NEW OPI CONFIGURATION

G-28807 C 09/12/06

Figure 1. Configuring the OPI and 22 kHz filters in series

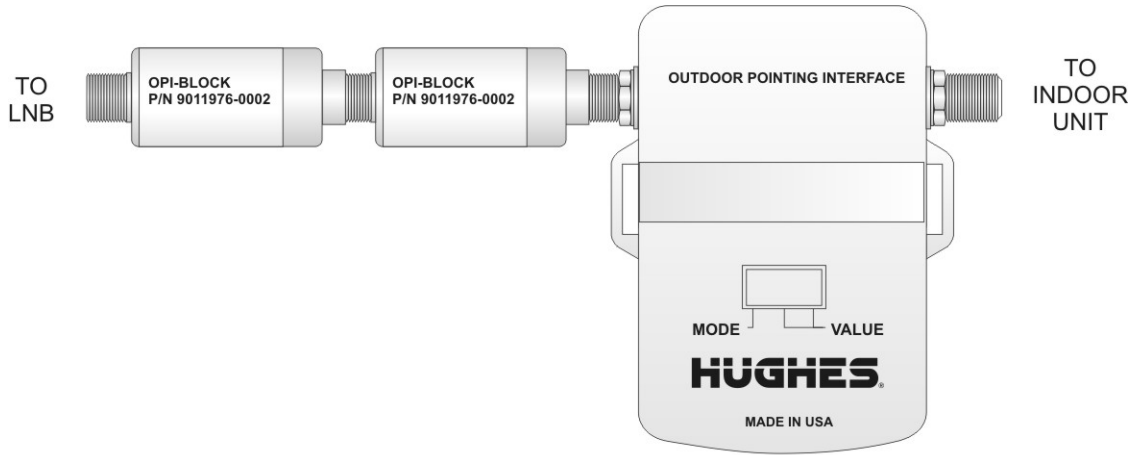
Use *two* 22kHz filters in series with your OPI device as shown in Figure 1. Use this configuration for all HughesNet products (DW40x0, DW6000, DW7X00, HN7x00).

Note: Hughes is supplying filters for this configuration change. Contact your distributor if you need a second filter.
